## Deviation from a Railway Group Standard

**Deviation Number: 14/093/DEV**

Class 387 Train Protection and Warning System (TPWS) Labelling.

**Figure 1 Measurement of angle subtended at the eye by 3mm text – worst case example for the 95<sup>th</sup> percentile British adult male.**

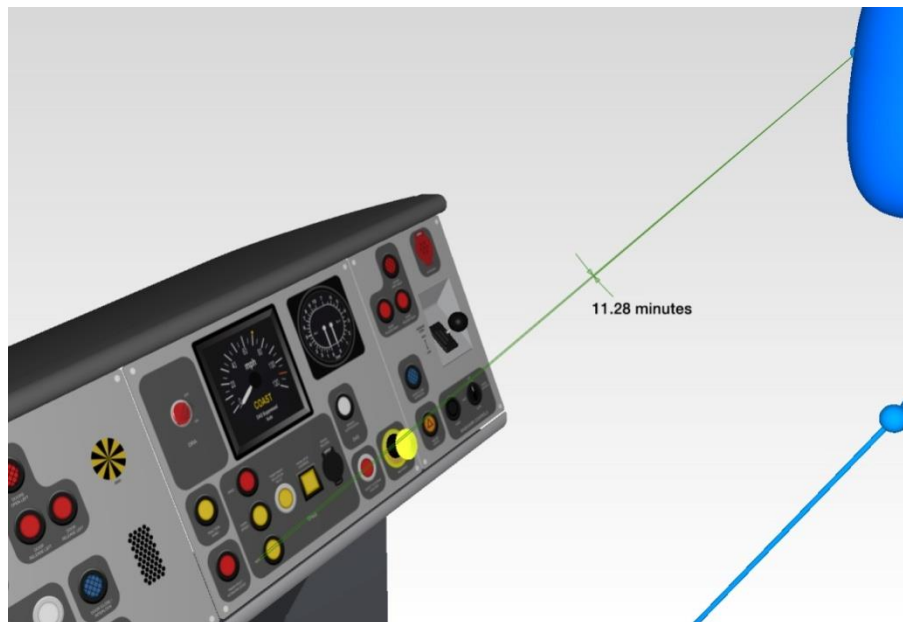
GE/RT8075 Clause F3.7 requires that the text labels subtend as a minimum a visual angle of 15 minutes when viewed from a driving position. The proposed labels have a character height of 3 mm, which is consistent with the labelling provided elsewhere in the cab. The proposed TPWS labels subtend an angle of between 11.3 and 12.1 minutes of arc as shown in Table 1 below. These values are measured on the 3D model using the eyepoint of the 95<sup>th</sup> percentile adult British male which represents the worst case driving position, i.e. the furthest reading distance as shown in Figure 1. This is comparable to and better than other indicators on the driver's desk such as the Safety Systems Isolated indicator and the Train Fault Acknowledge pushbutton.

Control/Indicator	Minutes of Arc subtended at the eye for the 95 <sup>th</sup> percentile male
AWS	11.3
Overspeed	11.5
SPAD	12.0
Temporary Isolation/Fault	12.1
Train Stop Override	12.0
Brake Release	12.1
Safety Systems Isolated	11.2
Train Fault Acknowledge	10.8
